<b>Illinois Tollway Base Sheet Revisions</b>
--

<b>Section M</b>	<b>Base Sheet Drawings</b>
------------------	----------------------------

<b>Drawing</b>	<b>Modification Summary</b>	<b>Effective: 03-01-2024</b>
<b>Plaza Electrical Work (Business System)-Series 2500</b>		
<b>M-BUS-2507A</b>	<b>Reserved</b>	
	This sheet was deleted due to duplication to drawing M-ITS-2518A	
<b>M-BUS-2507B</b>	<b>Reserved</b>	
	This sheet was deleted due to duplication to drawing M-ITS-2518B	
<b>M-BUS-2508A</b>	<b>Reserved</b>	
	This sheet was deleted due to duplication to drawing M-ITS-2519A	
<b>M-BUS-2508B</b>	<b>Reserved</b>	
	This sheet was deleted due to duplication to drawing M-ITS-2519B	
<b>M-BUS-2519B</b>	<b>Wiring Diagram - AET 1-Lane Layout</b>	
	Replace solid line at the base of the monotubes by dash line.	
<b>M-BUS-2536</b>	<b>Overhead Conduit Tray</b>	
	Revised: Concrete Base Plate Footing to say Concrete Base Plate Foundation	
	Added arrow with note saying: Backfilled by compacted earth	
	Added the symbol: diameter for 3/5" diameter x 10 foot 6 inches

**VES WASH SYSTEM SINGLE CABINET DETAIL**

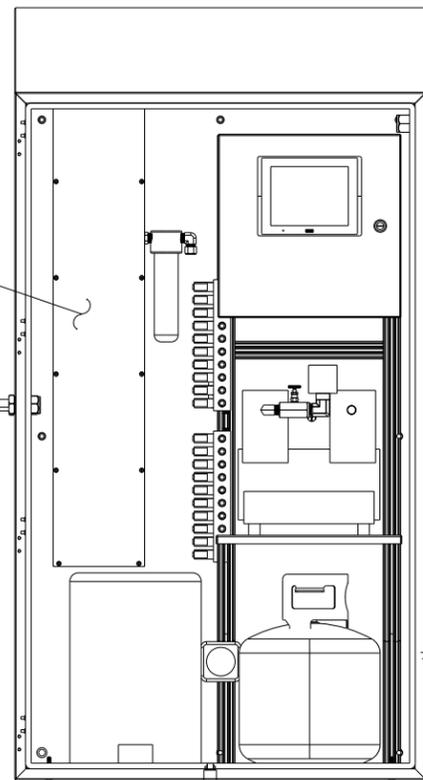
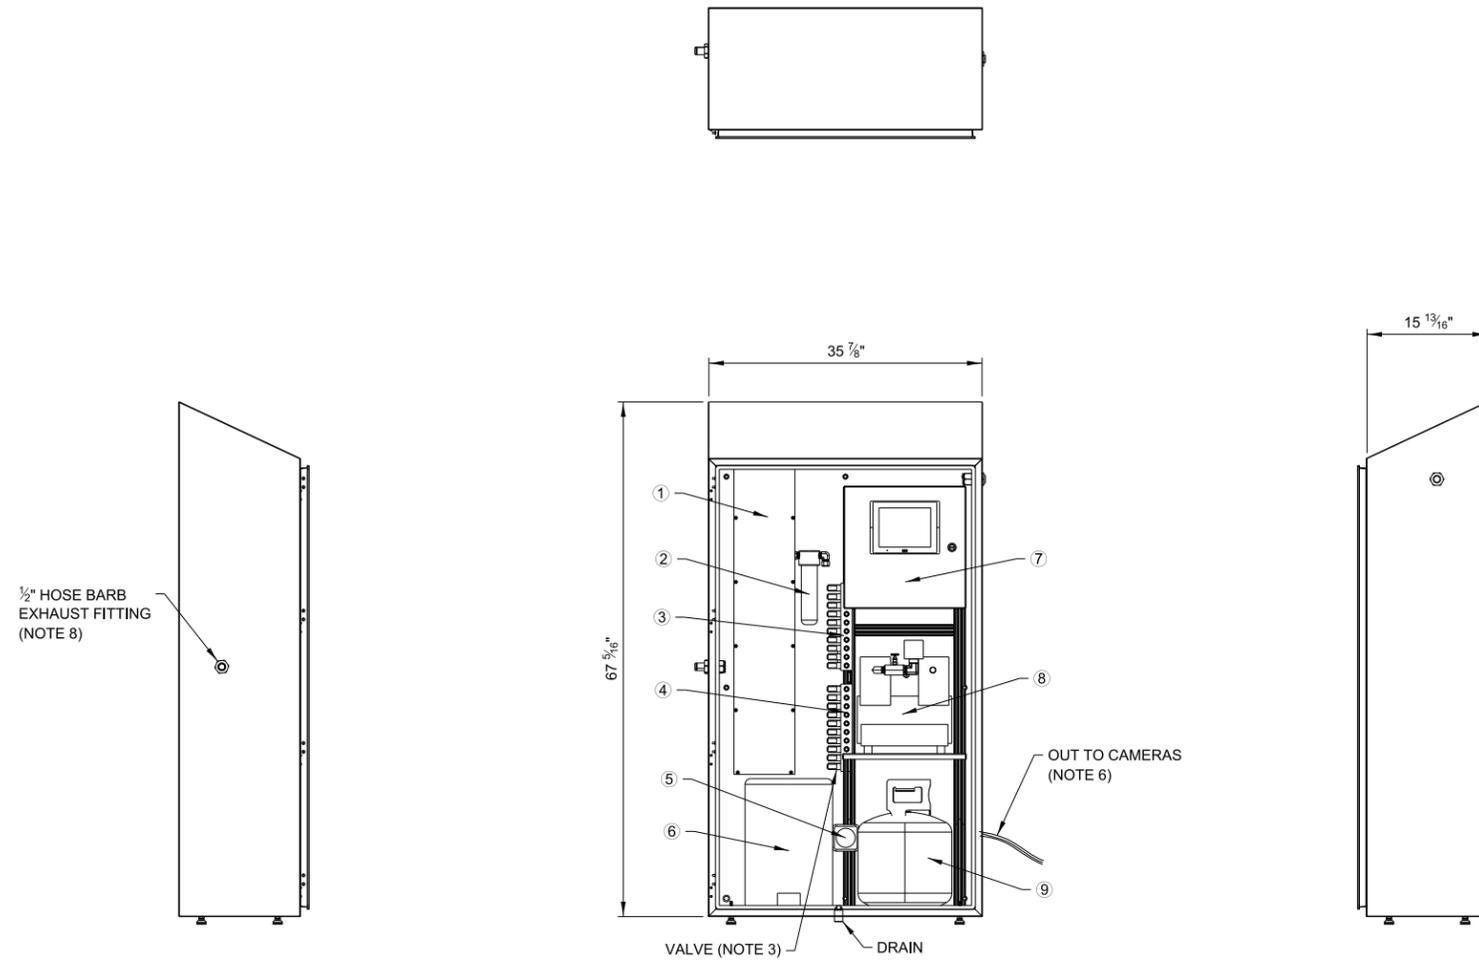
<b>M-BUS-2538</b>	<b>VES Wash System Single Cabinet Detail</b>	
	VES Wash cabinet redrawn to show VES Wash Single Cabinet System with Nitrogen generator	
	Removed the 4 old nitrogen cylinders and air compressor	
	Rearranged the VES Wash cabinet layout showing all the parts and description of each main components	
<b>M-BUS-2539</b>	<b>VES Wash System Panel Detail</b>	
	VES Wash Single Cabinet with Nitrogen Generator layout with notes and material list of components of the new cabinet	
	New representation of the VES Wash single cabinet layout with Nitrogen generator and part list.

**NOTE:**  
THE VES WASH SYSTEM WITH NITROGEN GENERATOR IS PRODUCED BY ECD COMPANY WITH THE MODEL NUMBER: NS-CMP-SY-4-0100, AS ASSIGNED BY ECD (OR APPROVED EQUAL MODEL BY THE ILLINOIS TOLLWAY BUSINESS SYSTEM).

\*\*\*FOR COMPLETE ASSEMBLY USE ECD # NS-CMP-SY-4-0100 (OR APPROVED EQUAL)\*\*\*
